Model: Russian-C4		Date: 20-Oct-05	No.: MB205001
Modified Article: NVRAM		Prepared by: S. Tomoe	
From: 1st Tech. Support Sec. Service Support Dept.			
Reason for Modification:	☒ Parts catalog correction ☐ To facilitate assembly ☐ Part standardization	☐ Vendor change ☐ To improve reliability ☐ Other	☐ To meet standards ()

Model: Russian-C4		Date: 2-Nov-05	No.: MB205002
Modified Article: Pressure Roller		Prepared by: S. Tomoe	
From: 1st Tech. Support Sec. Service Support Dept.			
Reason for Modification:	☒ Parts catalog correction ☐ To facilitate assembly ☐ Part standardization	☐ Vendor change ☐ To improve reliability ☐ Other	☐ To meet standards ()

Part Change Information List

Fig.1 (page 34)

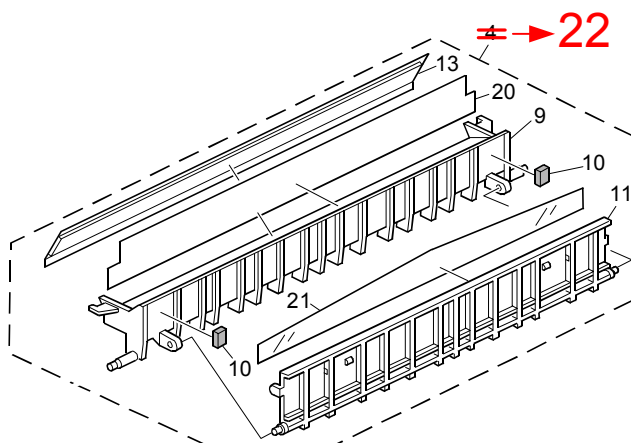
The illustration (Fig.1) has been changed.

Old part number	New part number	Description	Q'ty	Int	Page	Index	Note
	B2092741	Guide Plate: Entrance: Upper	0-1		35	22	Fig.1
	B0904462	Decal - C	0-1		45	24	Fig.2

Fig.1 (page 38)

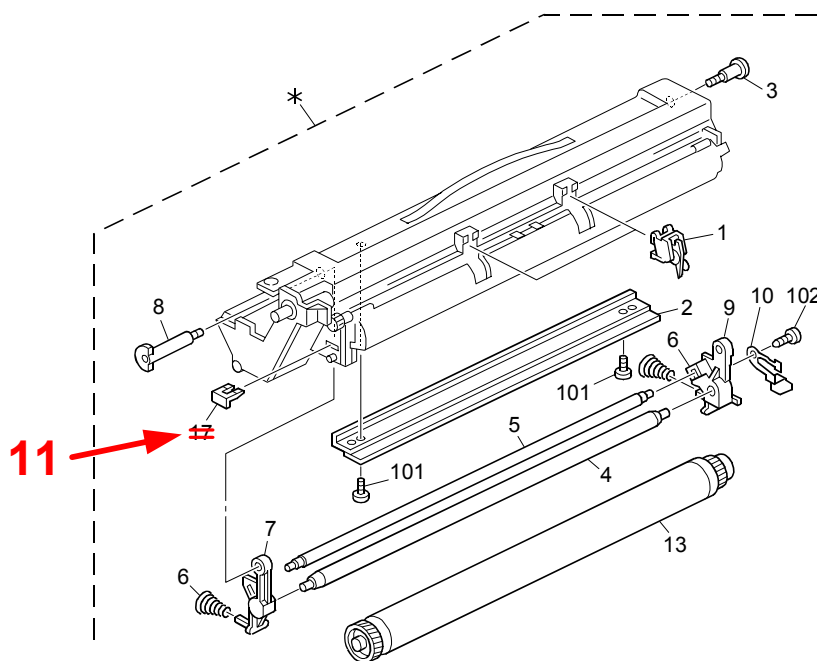
Old part number	New part number	Description	Q'ty	Int	Page	Index	Note
B2093300		Development Unit	1-1		39	11	Fig.1
	B0392350	Clip – OPC Drum

Old part number	New part number	Description	Q'ty	Int	Page	Index	Note
A2673440		Development Joint			39	12

Fig-1

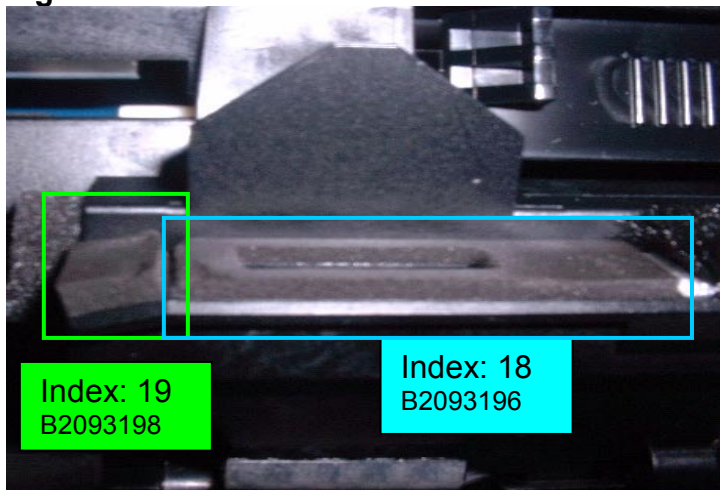
Old part number	New part number	Description	Q'ty	Int	Page	Index	Note
	B2093198	SHIELD:TONER SUPPLY:ENTRANCE:REAR	1		38	19	Fig1
	AA152297	SHIELD:TONER SUPPLY:ENTRANCE:FRONT	1		38	20	Fig2
	B2093360	DEVELOPMENT ROLLER CASE	1		38	21	Fig3
	B2093215	DRUM STAY:FRONT	1		38	22	Fig3
	B2093233	DRUM STAY:REAR	1		38	23	Fig3

Page 46

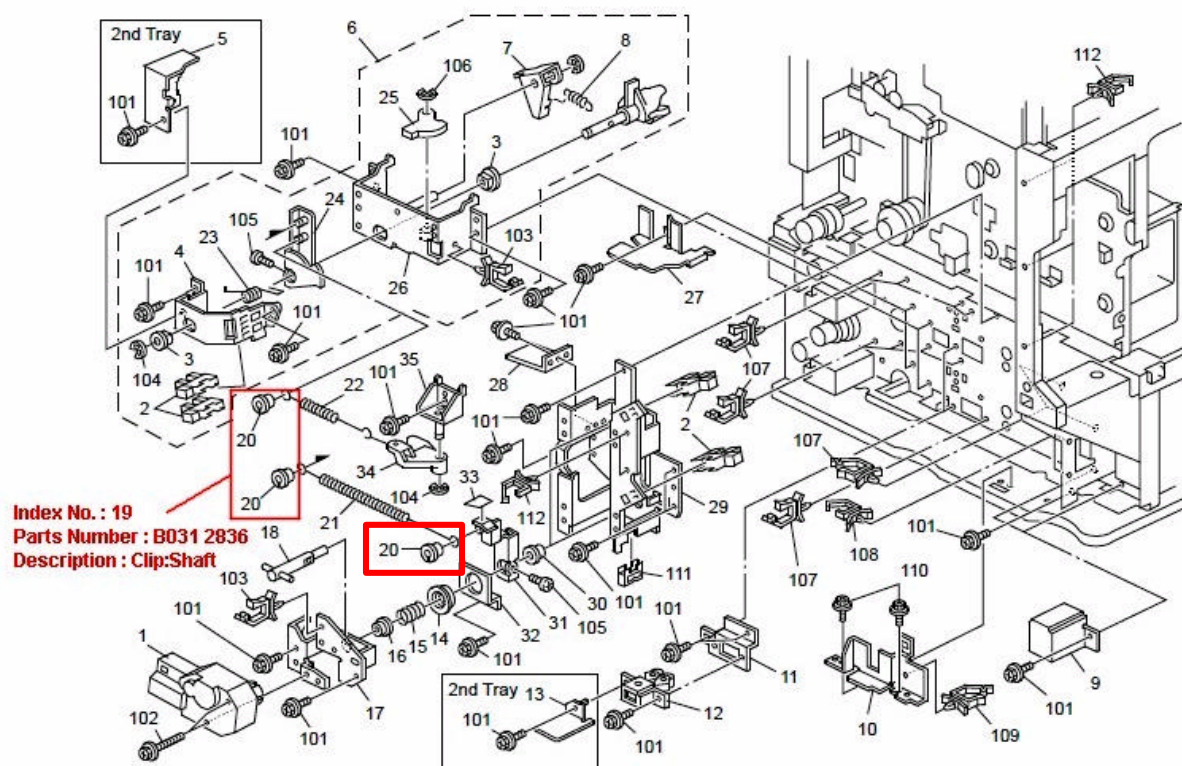
Change/Reason: The index number in the illustration was corrected (20→19).

Fig-1

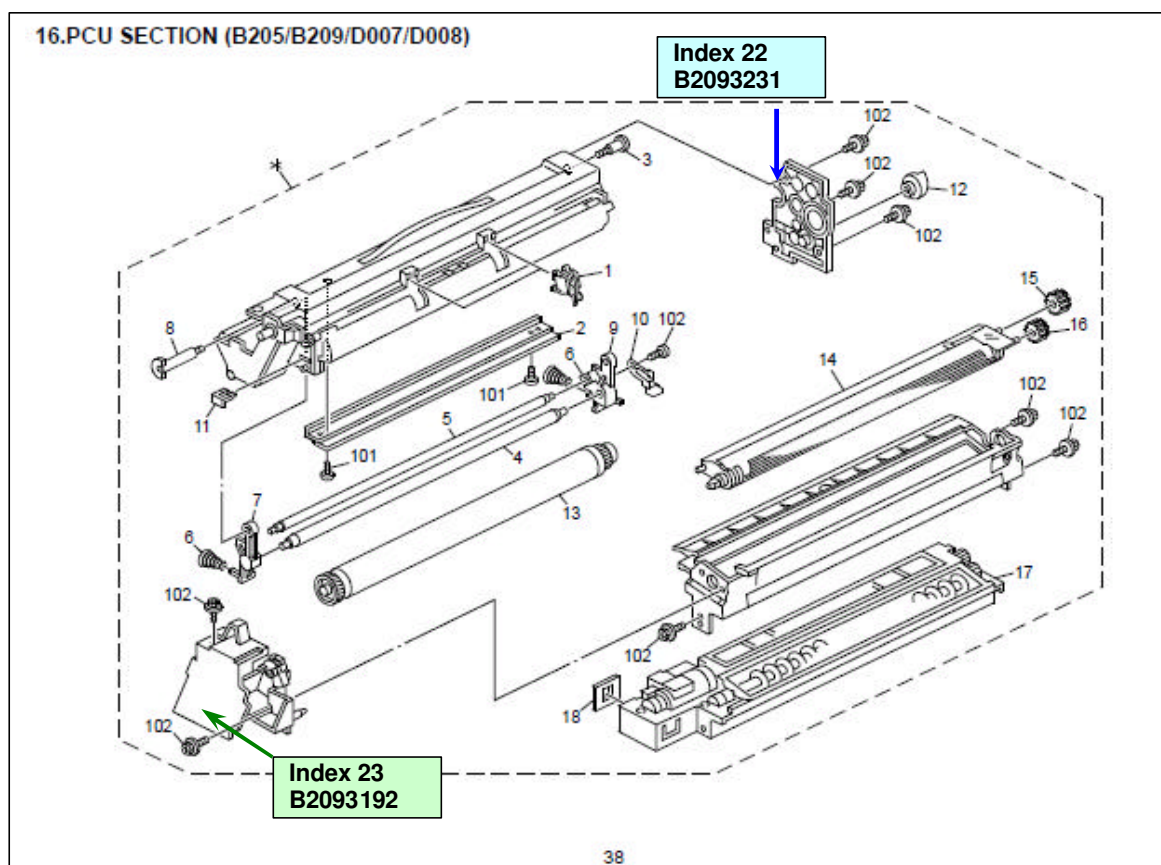
Old part number	New part number	Description	Q'ty	Int	Page	Index	Note
B2093215	<i>B2093231</i>	<i>DRUM STAY:REAR</i>	1		38	22	Fig1
B2093233	<i>B2093192</i>	<i>GRIP:PCU:FRONT</i>	1		38	23	Fig1

Fig-1

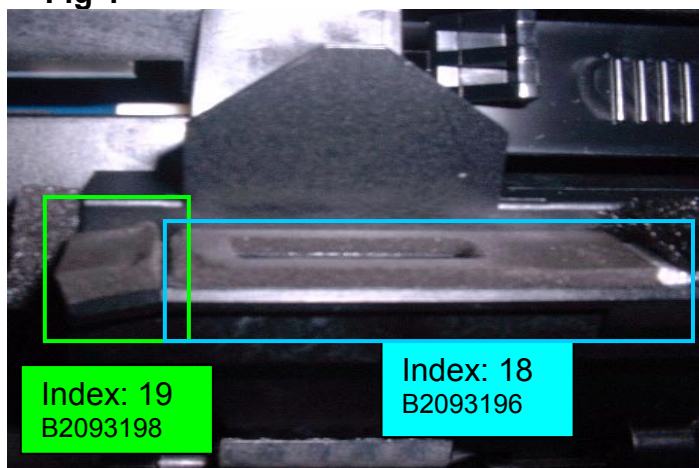
Old part number	New part number	Description	Q'ty	Int	Page	Index	Note
	B2093198	SHIELD:TONER SUPPLY:ENTRANCE:REAR	1		38	19	Fig1
	AA152297	SHIELD:TONER SUPPLY:ENTRANCE:FRONT	1		38	20	Fig2
	B2093360	DEVELOPMENT ROLLER CASE	1		38	21	Fig3
B2093231		DRUM STAY:FRONT	1		38	22	Fig3
↳	<i>B2093233</i>	<i>DRUM STAY:REAR</i>	1		38	22	Fig3
B2093233		DRUM STAY:REAR	1		38	23	Fig3
↳	<i>B2093215</i>	<i>DRUM STAY:FRONT</i>	1		38	23	Fig3
